MODIFICATION NOTICE

APR4 / SPR4 / APR5 / SPR5 > P 24 / 25 / 26 / 27

PC > P 110

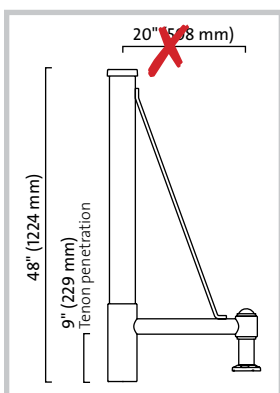
Correction:

The size of the **PC** bracket is **24" (610 mm)** and not 20" (508 mm).

DC6 / DC8 / DR6 / DR8 > P 121

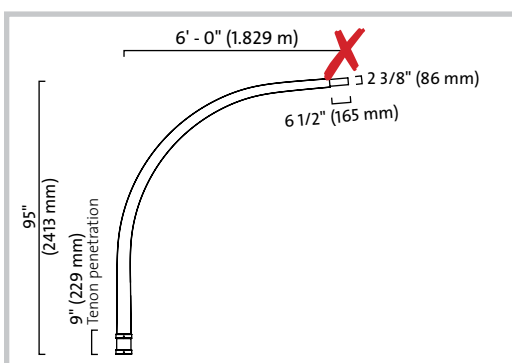
Correction:

The tenon is not included in the given size of the **DC** and **DR** brackets.

RTA61 > P 73

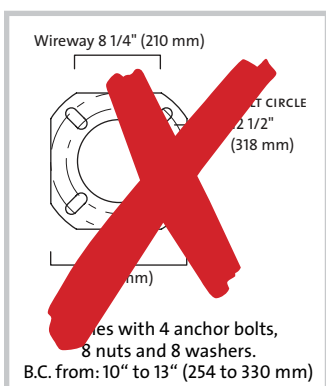
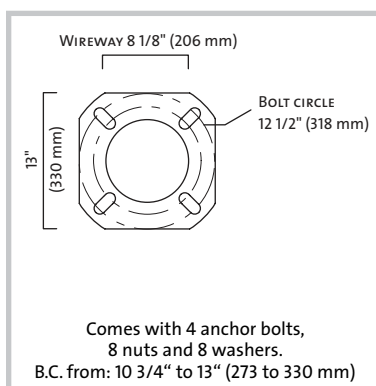
Comes with 4 anchor bolts, 8 nuts and 8 washers. B.C. from: 10" to 13" (254 to 330 mm)

Correction:

Here is the correct information on the anchor plate for the **RTA61** pole.

Comes with 4 anchor bolts, 8 nuts and 8 washers. B.C. from: 10 3/4" to 13" (273 to 330 mm)
